ACCESSION NBR: 9504140089      DOC. DATE: 95/04/06      NOTARIZED: YES      DOCKET #  
 FACIL: 50-261 H.B. Robinson Plant, Unit 2, Carolina Power & Light C      05000261  
 AUTH. NAME      AUTHOR AFFILIATION  
 KRICH, R.M.      Carolina Power & Light Co.  
 RECIP. NAME      RECIPIENT AFFILIATION  
                          Document Control Branch (Document Control Desk)

SUBJECT: Submits addl info re TS change re turbine overspeed protection valve testing frequency.

H. B. ROBINSON STEAM ELECTRIC PLANT, UNIT NO. 2  
DOCKET NO. 50-261/LICENSE NO. DPR-23  
ADDITIONAL INFORMATION FOR TECHNICAL SPECIFICATIONS CHANGE  
RELATED TO TURBINE OVERSPEED PROTECTION VALVE TESTING FREQUENCY

### RESPONSE TO NRC QUESTIONS

Figure 2

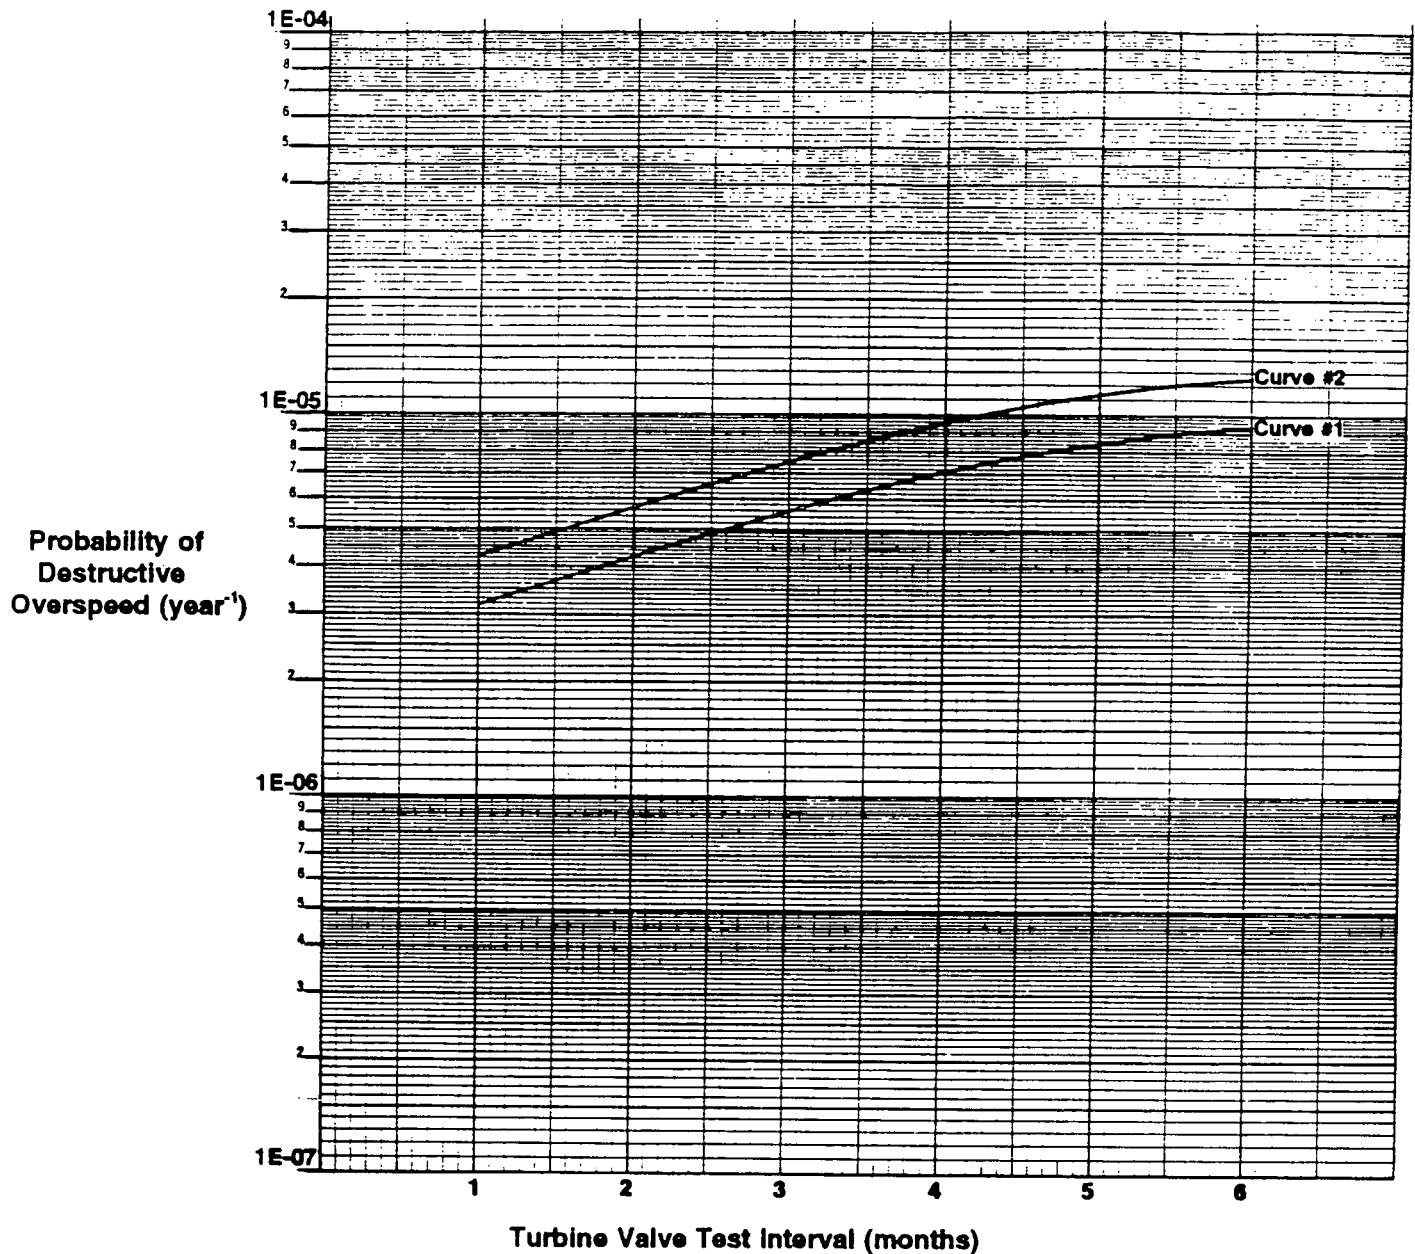
Surveillance of stop valve discs is performed on a refueling interval basis. HBRSEP has no installed means of on-line surveillance testing of the stop valve discs. The stop valve surveillance interval is comparable to Curve #1 of Figure 2 of the WOG Final Report. In this figure, a probability of destructive overspeed of  $5.6\text{E-}06$  per year is given for quarterly testing. The actual surveillance interval for stop valve discs is more frequent (i.e., 15 months versus 18 months) than the WOG Final Report assumption in Figure 2, Curve #1. No actual failures of stop valves have been experienced among the 16 subgroup units since the Pacific Gas & Electric Company Diablo Canyon Power Plant event of September 12, 1992. The implementation of OMM 108 at HBRSEP is expected to provide additional assurance that disc failure is not a failure mode. For these reasons, the actual probability of destructive overspeed at HBRSEP is expected to be well below the WOG Final Report acceptance criterion of  $5.0\text{E-}06$  per year.<sup>2</sup>

Figure 3

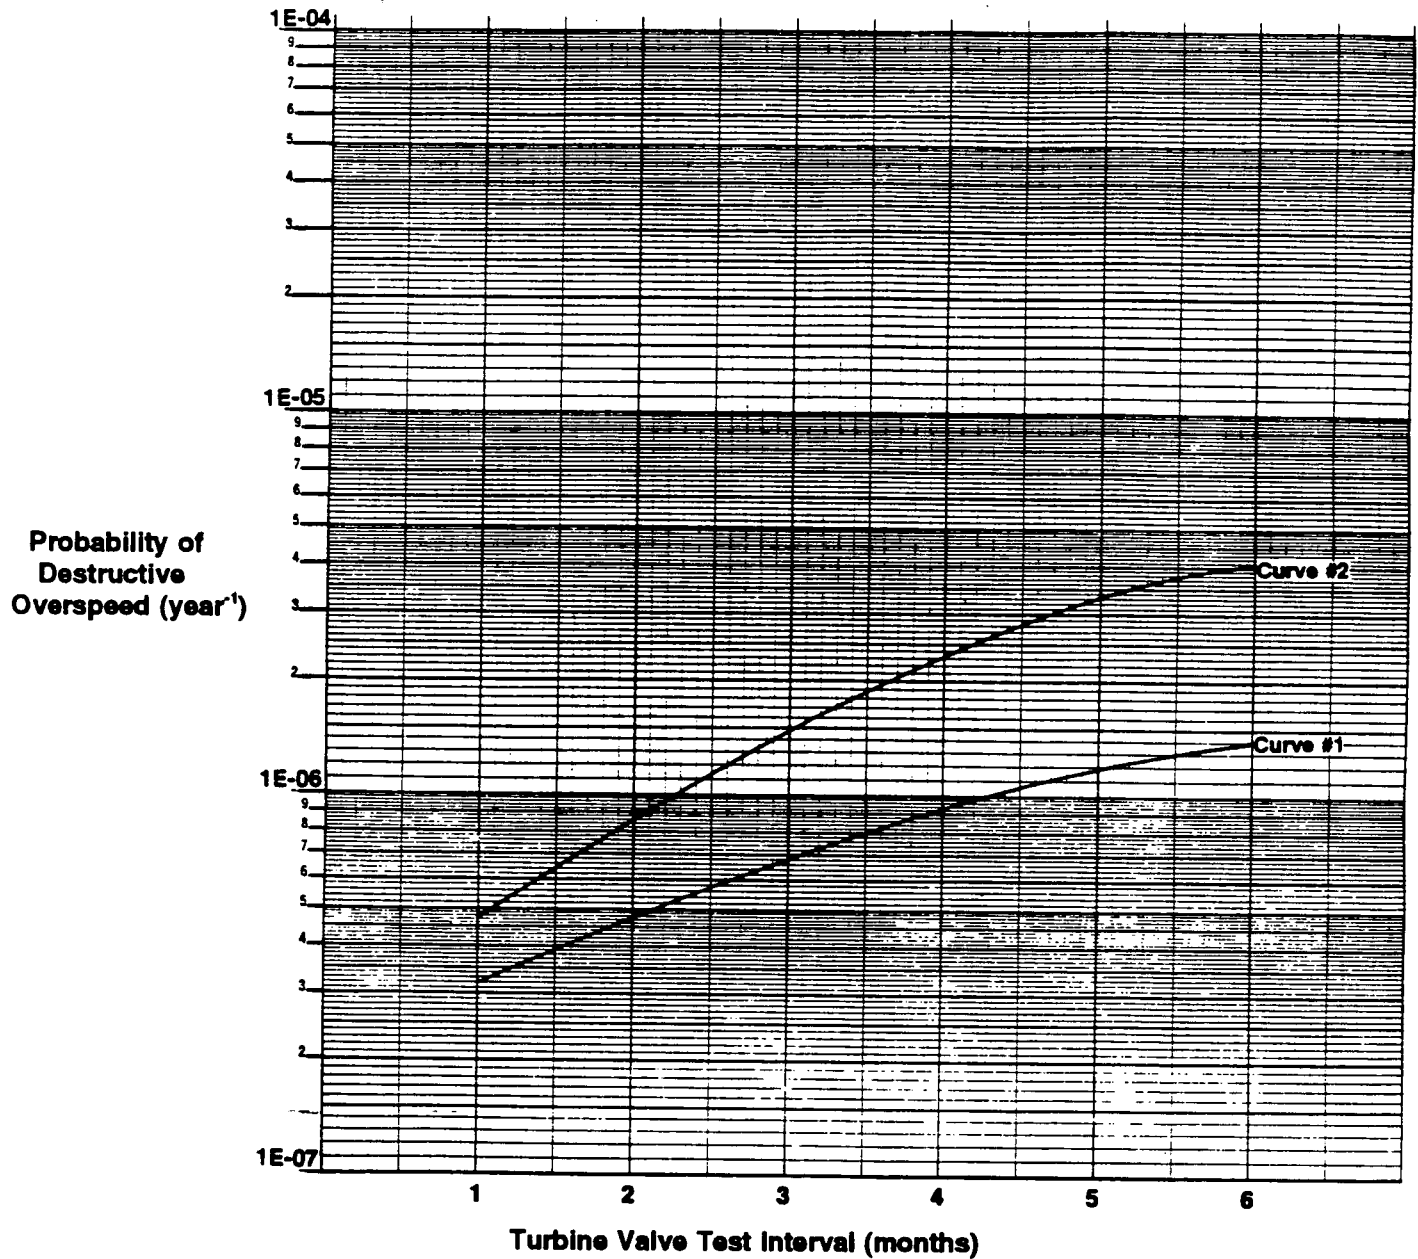
We conclude that HBRSEP is bounded by the assumptions and results of WCAP-11525 and the WOG Final Report, and that quarterly testing of the turbine overspeed valves will maintain the annual frequency of destructive overspeed below the WOG Final Report acceptance criteria of  $5.0E-06$  per year, utilizing Figure 3, Curve 2 of the WOG Final Report.

In summary, HBRSEP is bounded by the assumptions and results of WCAP-11525 and the WOG Final Report, and quarterly testing of the turbine overspeed valves will maintain the annual frequency of destructive overspeed below the WOG Final Report acceptance criteria of  $5.0\text{E-}06$  per year, utilizing Figure 3, Curve 2 of the WOG Final Report.
